**AMENDMENT NO. 8 TO
AGREEMENT BETWEEN
THE CITY OF NORFOLK
AND
ARCADIS U.S., INC.
FOR
NATIONAL DISASTER RESILIENCE COMPETITION (NDRC) –
OHIO CREEK – DESIGN SERVICES**

Subject:
National Disaster Resilience Competition (NDRC) Ohio Creek Design Services:
Scope of Services for Amendment 8 – Construction Phase Services; Additional
Services
City e-Builder Project No. 17011; Contract No. 26367

The Arcadis U.S., Inc. ("Arcadis") team is pleased to provide you with a scope of services for Amendment 8, Construction Phase Services Additional Services – Construction Phase Services for the NDRC Ohio Creek Design Services Contract No. 26367.

ATTACHMENT: RENDERING TO BE REVISED

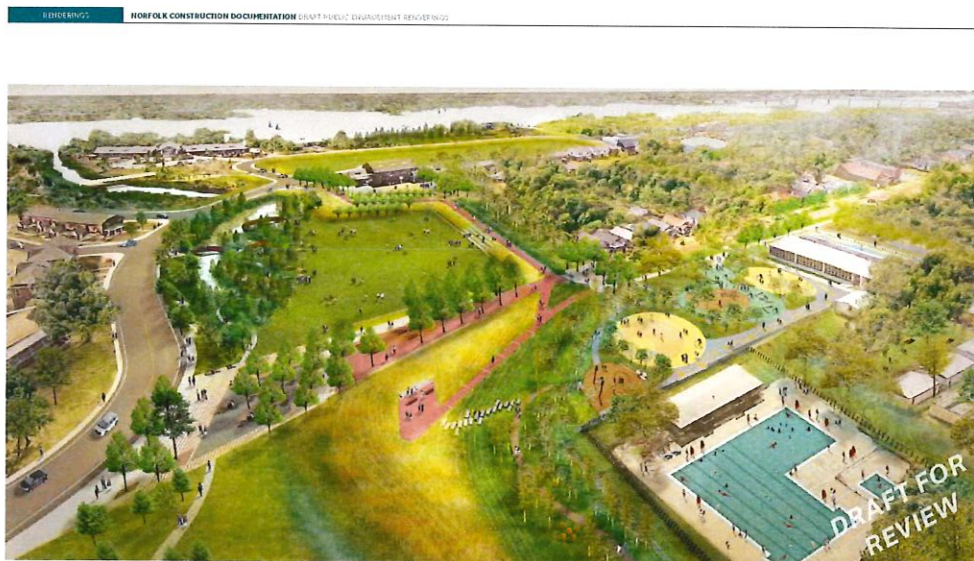
Prepare revised birds eye rendering of the resilience park based on value engineering (VE) design revisions.

- Once SCAPE has received confirmation of all of the proposed design revisions for the resilience park, SCAPE will revise the attached birds-eye rendering of the park to reflect these design revisions.
- SCAPE assumes one (1) round of review and comment on the revised rendering. SCAPE will participate in up to one (1) call with ARCADIS and the City to review and discuss comments on the rendering.
